**Work Order ID 65510**

Item Name: 205 Skidtube bent detail

DRAWING NO. D2580	TITLE 205 SKIDTUBE ASSEMBLY	REV. D	DART AEROSPACE LTD ENGINEERING ORDER		D.E.O. NO. D2580-D-1	SHEET NO. SHEET 1 OF 1	SCALE NTS
DRAWN <i>UP</i>	CHECKED <i>L</i>	MFG. APPR. <i>E</i>	APPROVED <i>MP</i>		DE APPR. <i>#</i>		
DATE 10.09.22	DATE 10.11.04	DATE 10.11.04	DATE 10/11/04		DATE 10.11.04

CHANGE ALL WELDED CROSSBOLT SPACERS TO SWAGED SPACERS

SECTION D-D & SECTION H-H ARE AMENDED AS FOLLOWS:

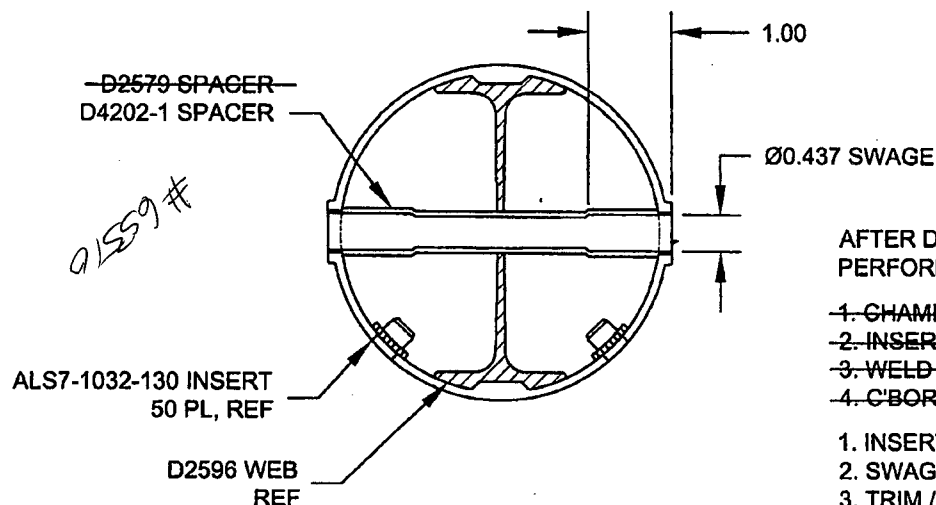
AFTER DRILLING AND BENDING ASSEMBLY  
PERFORM THE FOLLOWING FOR Ø0.508 HOLES ONLY:

1. CHAMFER HOLE 0.050 X 45°
2. INSERT D2579 SPACER (20 PLACES)
3. WELD INTO PLACE AND GRIND FLUSH
4. C-BORE D2579 SPACER TO Ø0.437 X 1.00 DEEP

1. INSERT D4202-1 SPACER, 20 PL (-041) OR 24 PL (-045)
2. SWAGE TO Ø0.437 X 1.00 DEEP PER QSI 002
3. TRIM / GRIND FLUSH PER QSI 002
